Historic Preservation Commission Agenda

ITEM: 1155 Pine Street Landmark & Alteration Certificate Request

REQUEST: A request to landmark the building at 1155 Pine Street, and request for an alteration certificate.

SHEET NAME:	EXHIBIT 1c
BUILDING ELEVATIONS	MARCH 5, 2025

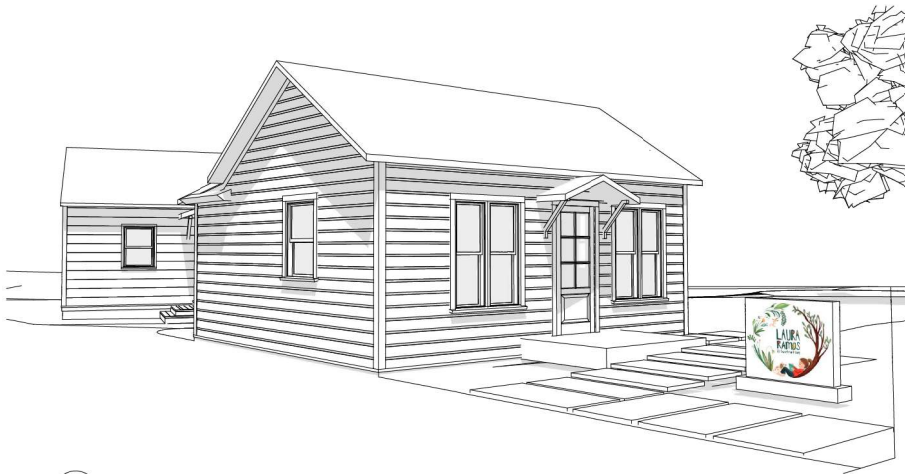
8. a. <i>A property shall be used for its historic purpose or be placed in a new use that requires minimal change to the defining characteristics of the building and its site and environment.</i>	No	Several alterations are proposed for the building to satisfy a commercial-oriented live-work use not historically intended for the building. This has resulted in alternations such as enlarged windows not characteristic of the historic use.

8. b. <i>The historic character of a property shall be retained and preserved. The removal of historic materials or alteration of features and spaces that characterize a property shall be avoided.</i>	No	The front windows are proposed to be altered to satisfy commercial design standards as part of the active Planned Unit Development application.
